STAFF RECOMMENDATION 1623 Sumner Avenue June 19, 2019

Application: New Construction—Infill
District: Eastwood Neighborhood Conservation Zoning Overlay
Council District: 06
Map and Parcel Number: 08306002800
Applicant: Rob Cushman
Project Lead: Melissa Sajid, melissa.sajid@nashville.gov

Description of Project: Application is to revise previously approved infill development.

EXTERIOR ELEVATIONS - REVISED 5
1623 Sumner Av | MC2 Group, Inc

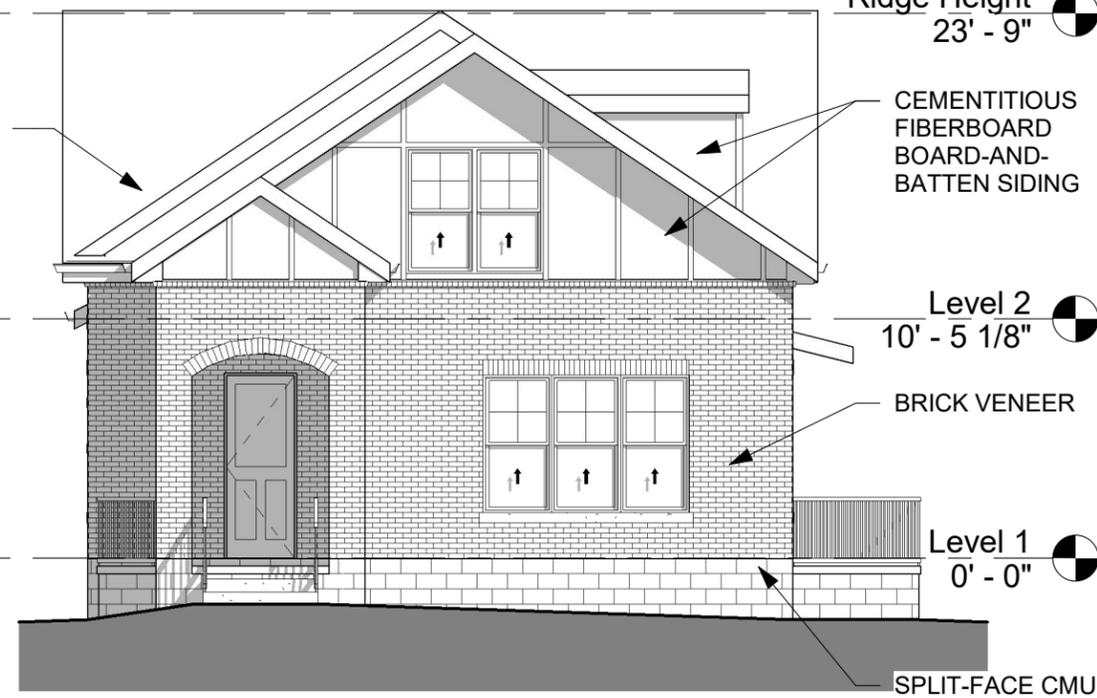
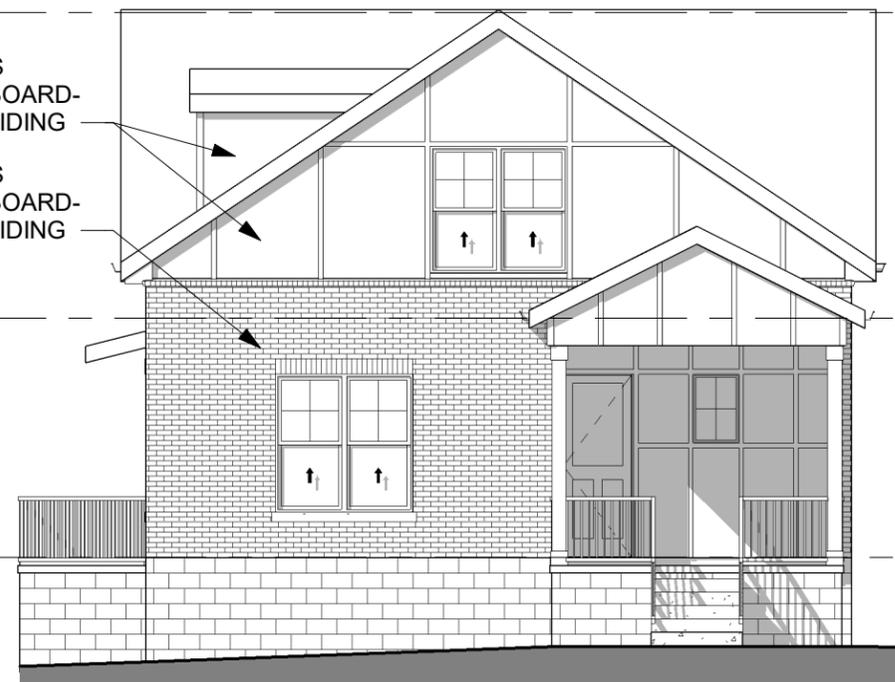
Height & Scale: The proposed infill is one-and-a-half stories in height with an eave height of approximately twelve feet (12') above the foundation and a ridge height of twenty-three feet, nine inches (23'9") above the foundation. The foundation is drawn on the plans as being approximately two feet (2'); staff recommends inspection of the foundation height and finished floor height to ensure compatibility with the historic context. Staff finds that the proposed height of the infill meets the historic context, where historic houses are one to one-and-a-half stories and range in height from eighteen to twenty-four feet (18'-24').

Roof form: The infill’s primary roof form is a cross gable with an 8/12 pitch. Two small gabled dormers are proposed for the right side façade, and both dormers were set in two feet (2’) from the wall below. The front porch will be gabled with a 6/12 slope. Staff finds that the proposed roof forms meet Section II.B.1.e. of the design guidelines.

Proportion and Rhythm of Openings: The windows on the proposed infill are all generally twice as tall as they are wide, thereby meeting the historic proportions of openings, and there are no large expanses of wall space without a window or door opening. With the inclusion of four to six inch (4”-6”) mullions on all paired or triple window openings, staff finds the project’s proportion and rhythm of openings to meet Section II.B.1.g. of the design guidelines.

1. The finished floor height shall be consistent with the finished floor heights of the adjacent historic houses, to be verified by MHZC staff in the field;

4. Staff shall approve a brick sample prior to purchase and installation;
5. A walkway shall be added from the street to the front porch;
6. All paired window openings shall have four to six inch (4"-6") mullions between them; and
